Re: The Residences of South Brookline (the “Development”)  
Comprehensive Permit – Request for Insubstantial Change

RESIDENCES OF SOUTH BROOKLINE  
MINOR MODIFICATION  
Brookline, MA

**Residences of South Brookline**  
**Outline of Proposed Changes via Request for Minor Modification**  
**March 19, 2019**

BUILDINGS 2,5,6,7,8 & 9

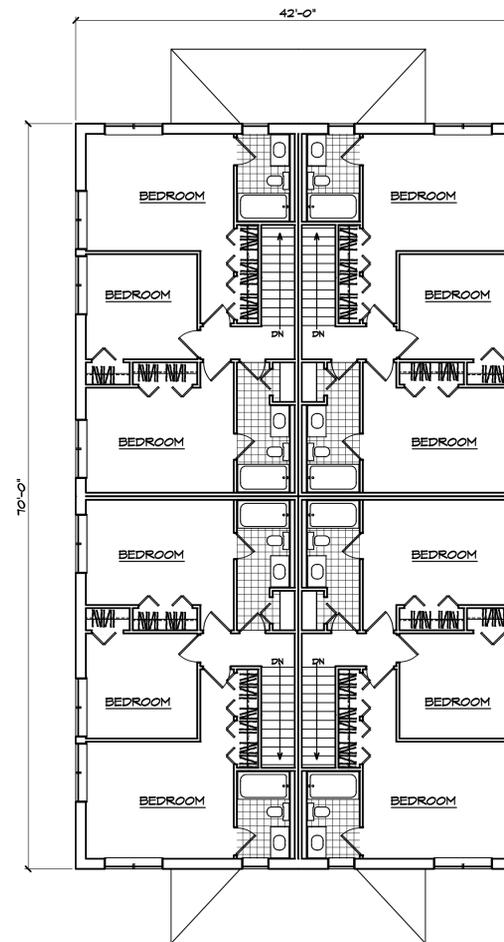
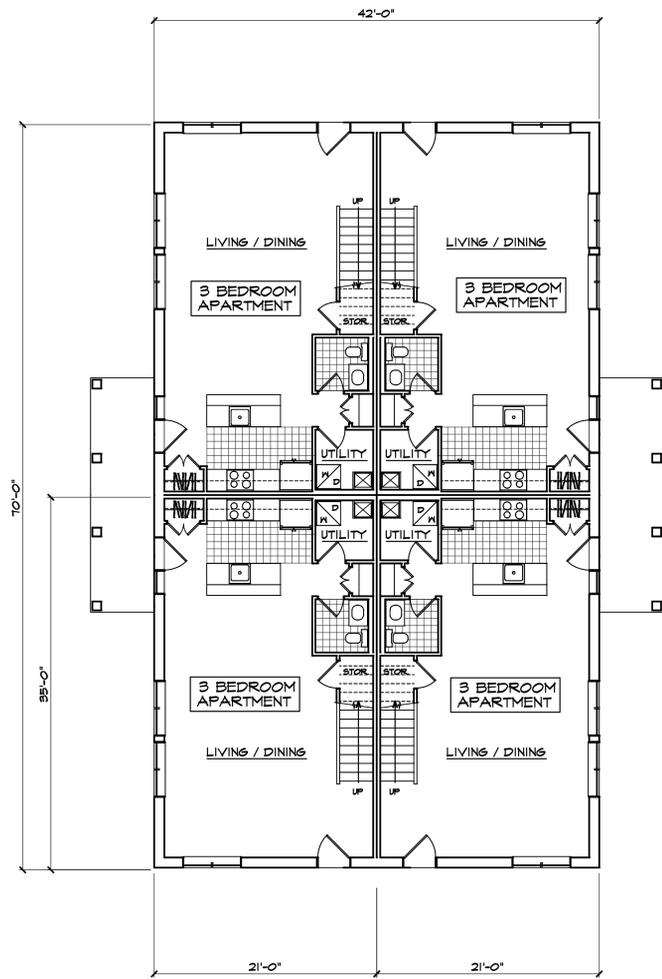
(a) The height of each S-7 Building will be reduced from three stories to two stories. The footprint of each S-7 Building will be decreased and the orientation of certain S-7 Buildings will be modified as shown on the Modified Site Plan.

**APARTMENT BUILDING  
 LOWER LEVEL  
 GARAGE PLAN**

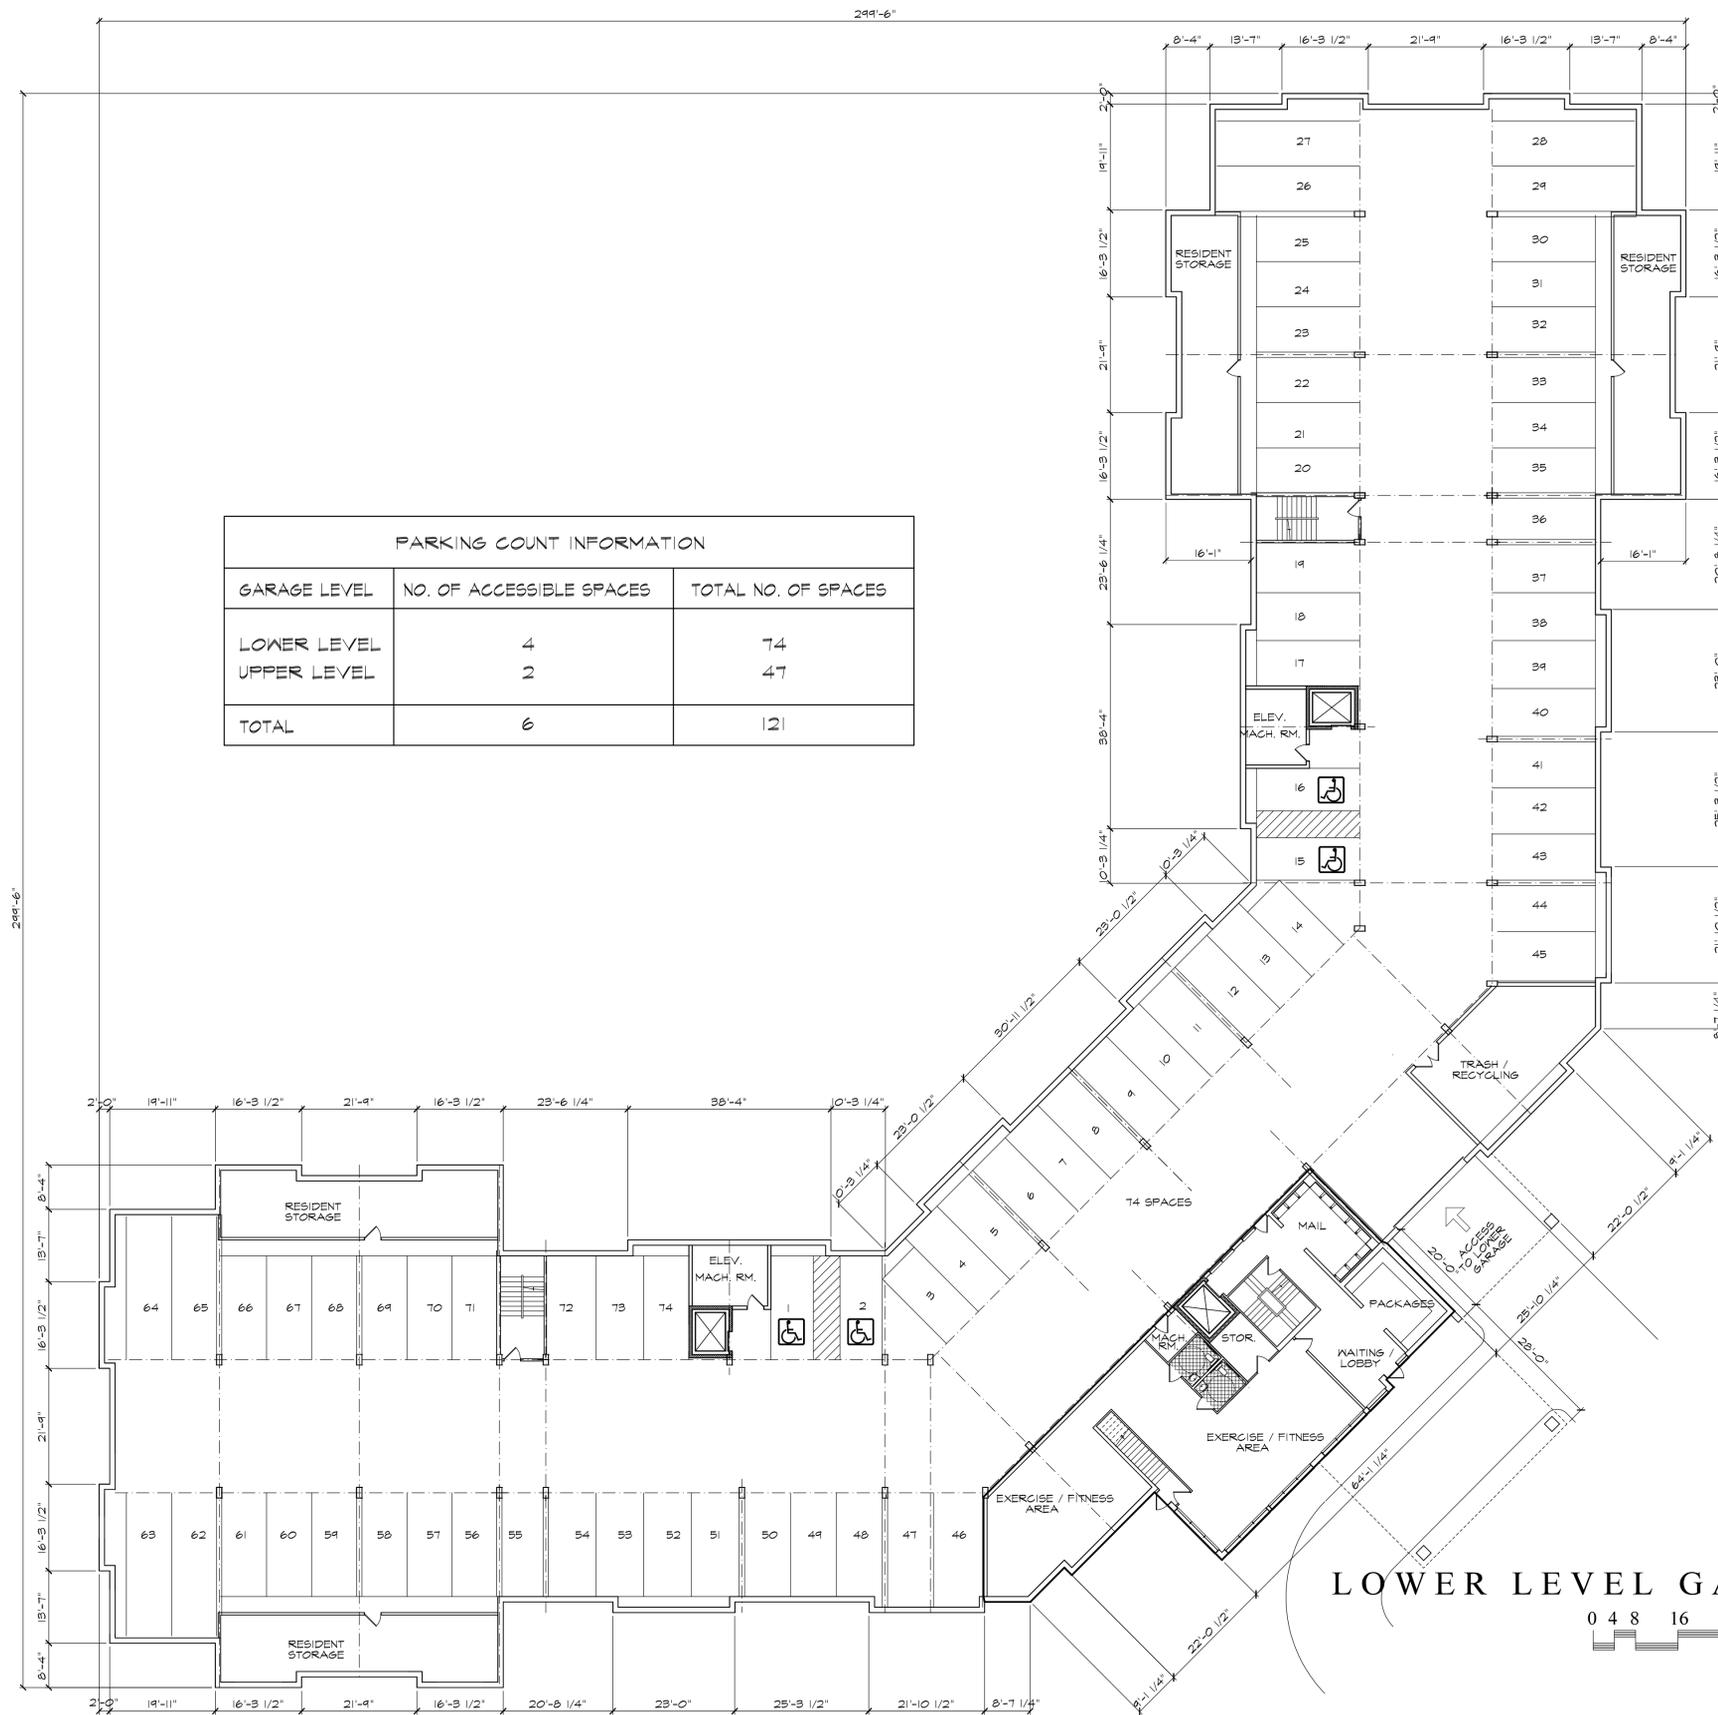
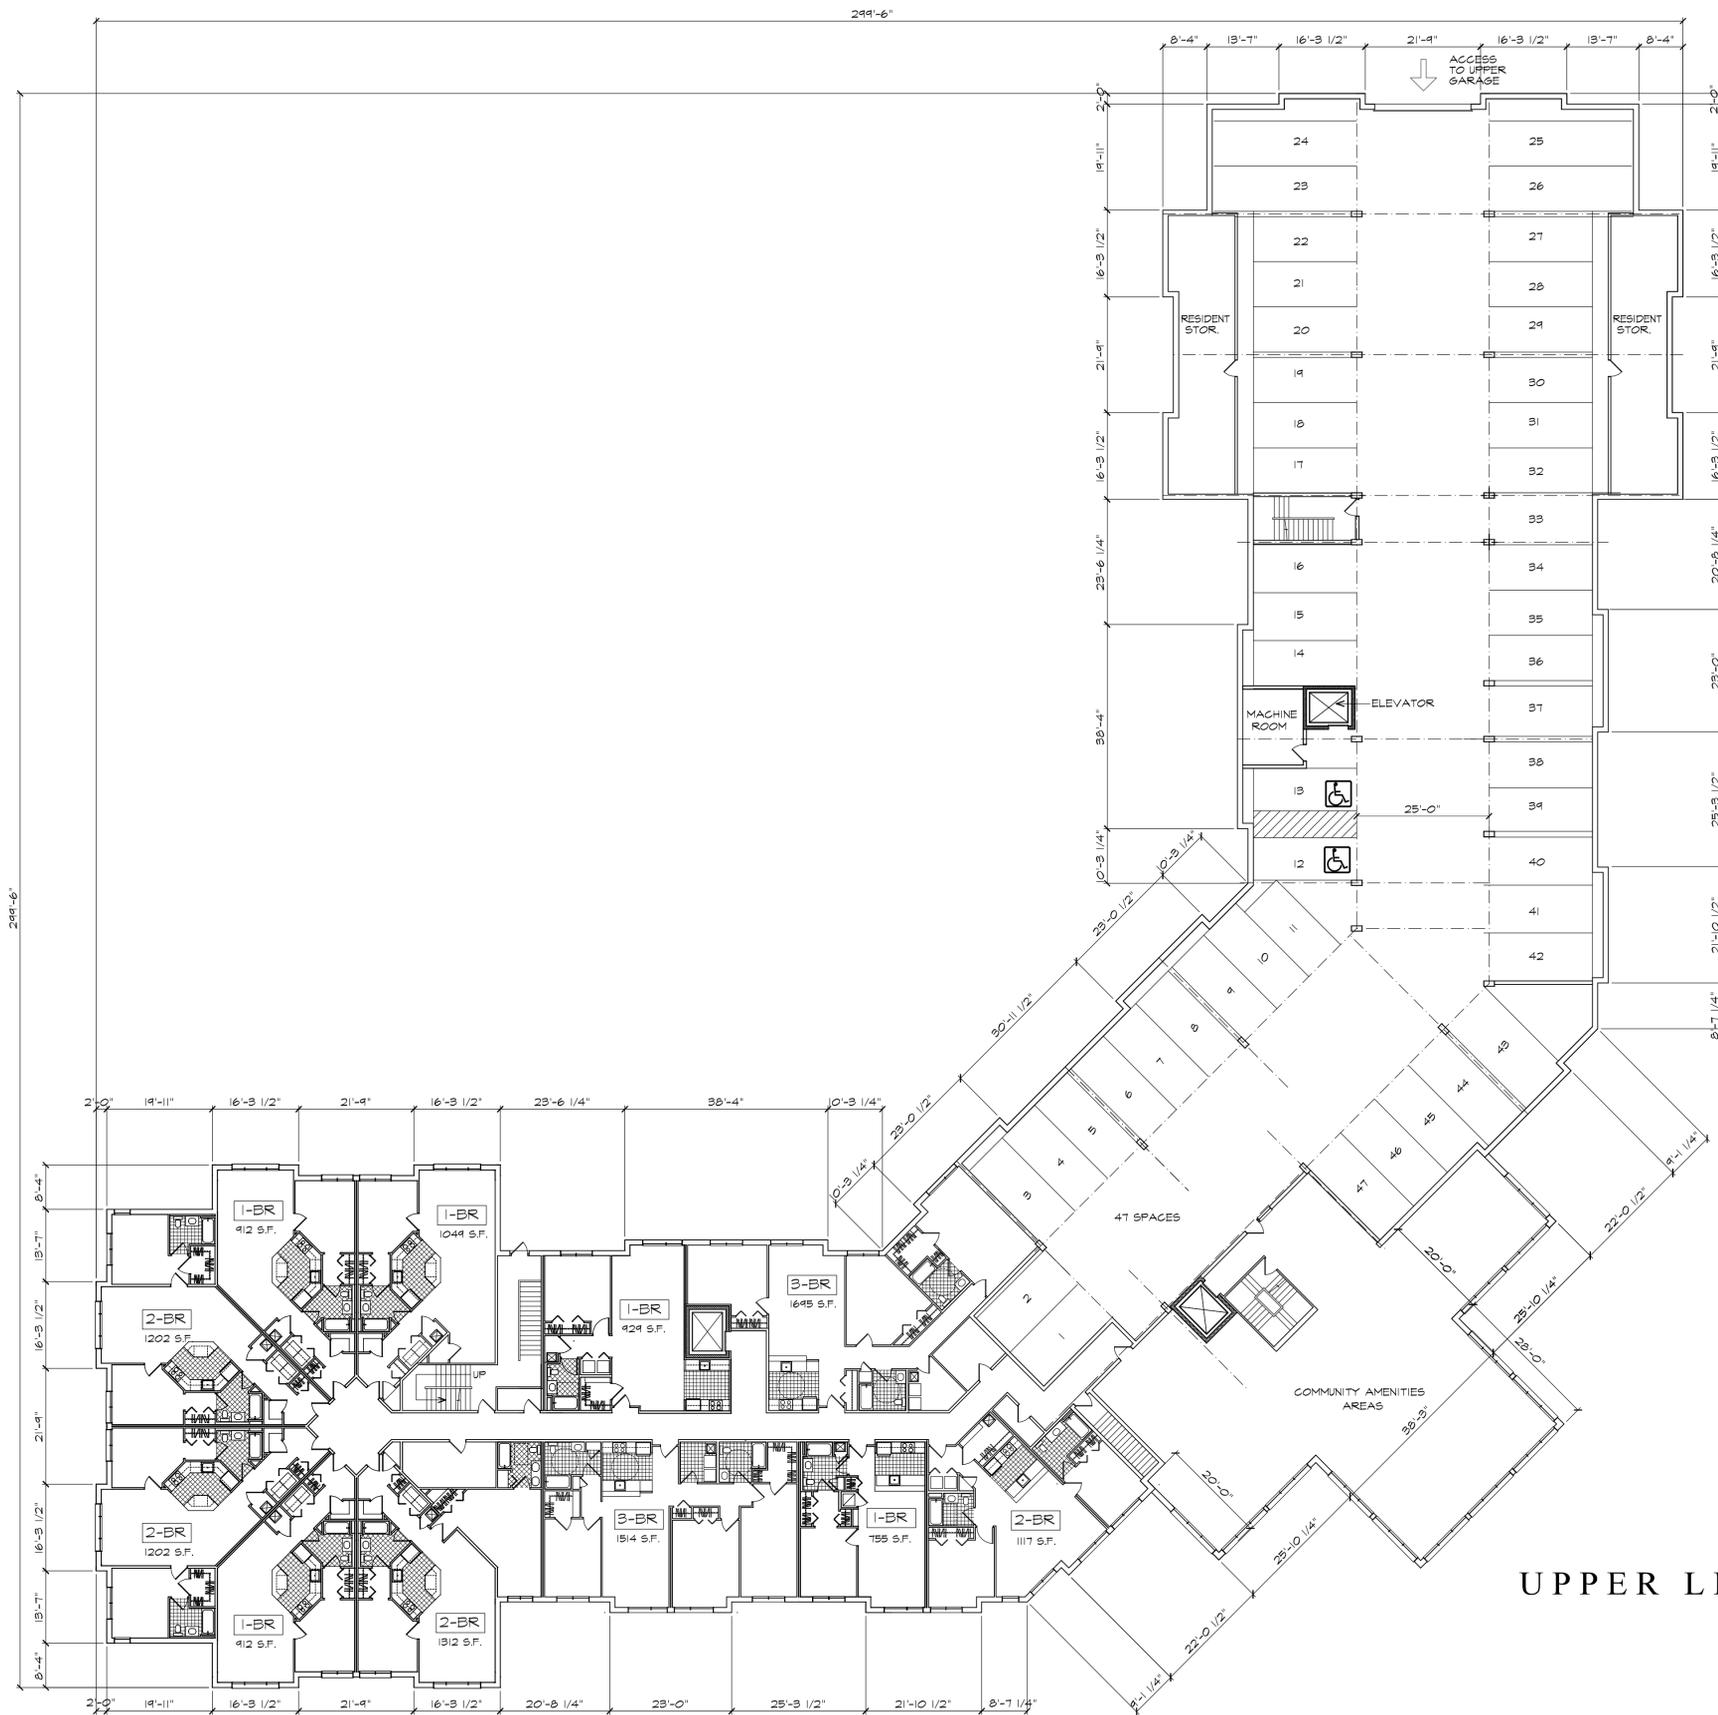
- Increase of 26 one bedroom units – (from 53 to 79)
- Decrease of 13 two bedroom units – (from 56 to 43)
- Introduction of 2 three bedroom units and 3 studios
- Increase in GFA of 12,369 (upper garage level units)
- Garage spaces increased from 99 to 121 (parking ratio unchanged)
